Item ID: D212-664-101TRN

Item Name: Crosstube Turning Detail

DART AEROSPACE LTD		Work Order:	105916
Description: Crosstube Assembly (205/212/412 High Fwd)		Part Number:	D212-664-141
Inspection Dwg: D212-664-141 Rev: D		Page 1 of 2

DRAWING NO. D212-664-141	TITLE XTUBE ASSY (205/212/412 HI FWD)	REV. D	DART AEROSPACE LTD ENGINEERING ORDER		D.E.O. NO. D212-664-141-D-1	SHEET NO. SHEET 1 OF 2	SCALE NTS
DRAWN	CHECKED	MP	MFG. APPR.	APPROVED	MP	DE APPR.	
DATE 11.04.07	DATE 11.04.11		DATE 11.04.12	DATE 11/04/12		DATE 11.04.12

**D212-664-141/-141B
ASSEMBLY DETAIL**

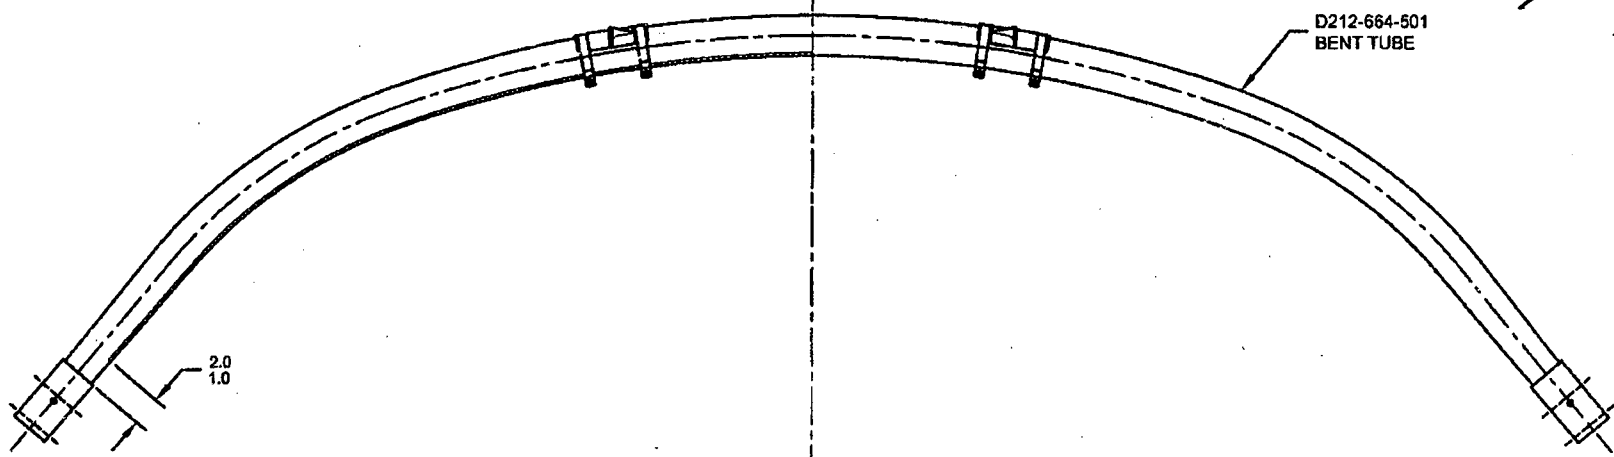
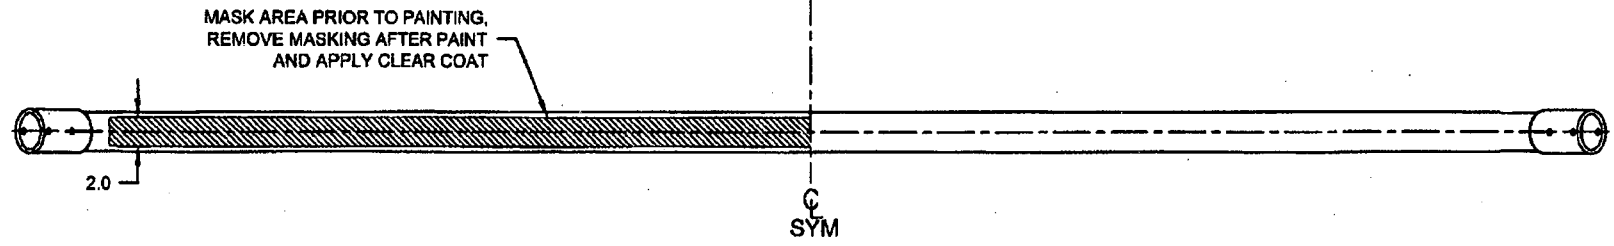
PURPOSE:

ADD AN INSPECTION WINDOW TO UNDERSIDE OF CROSSTUBE.

NOTES 2 OF SHEET 1 IS AMENDED AS FOLLOWS:

- 2) FINISH: CHEMICAL CONVERSION COAT PER DART QSI 005 4.1
PRIME INSIDE AND OUTSIDE PER DART QSI 005 4.2
MASK UNDERSIDE OF CROSSTUBE AS SHOWN (HATCHED AREA) AND
PAINT OUTSIDE PER DART QSI 005 4.2
REMOVE MASKING AND APPLY CLEAR COAT

- 2) FINISH: CHEMICAL CONVERSION COAT PER DART QSI 005 4.1
PRIME INSIDE AND OUTSIDE PER DART QSI 005 4.2
PAINT OUTSIDE PER DART QSI 005 4.2
